# Access Compliance Report

## Public Rights-of-Way

### (Pedestrian Signals)

| ADA ID: 44B27C8CC793                    | Signal Type: Two Push Buttons-Non APS | Overall Compliance: No                  | Severity Score: BTN 1:N/A BTN 2: N/A No BTN: N/A |

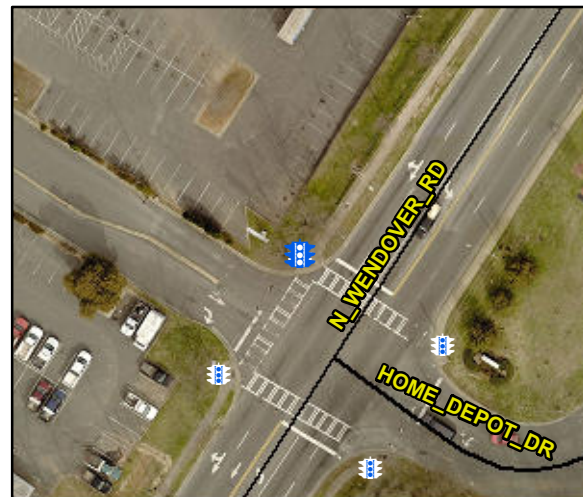
| Compliance | Description                             | Data    | Compliance | Description                            | Data |
|------------|-----------------------------------------|---------|------------|----------------------------------------|------|
| No         | B 1 Clear Floor Space XSlope (%)        | 6.0     | No         | B 2 Clear Floor Space XSlope (%)       | 5.4  |

| Yes | B 1 Clear Xing Direction? | ClearlyMarked | Yes | B 2 Clear Xing Direction? | ClearlyMarked |
|-----|---------------------------|---------------|-----|---------------------------|---------------|
| No  | B 1 DistanceTo Curb (in)  | 98.0          | No  | B 2 DistanceTo Curb (in)  | 98.0          |

Possible Solutions: Replace Signal Push Button With APS Button on New Post. Remove & Relocate Sign.

PROW/ADA: TMUTCD 4e.08, R404.2, R406.2
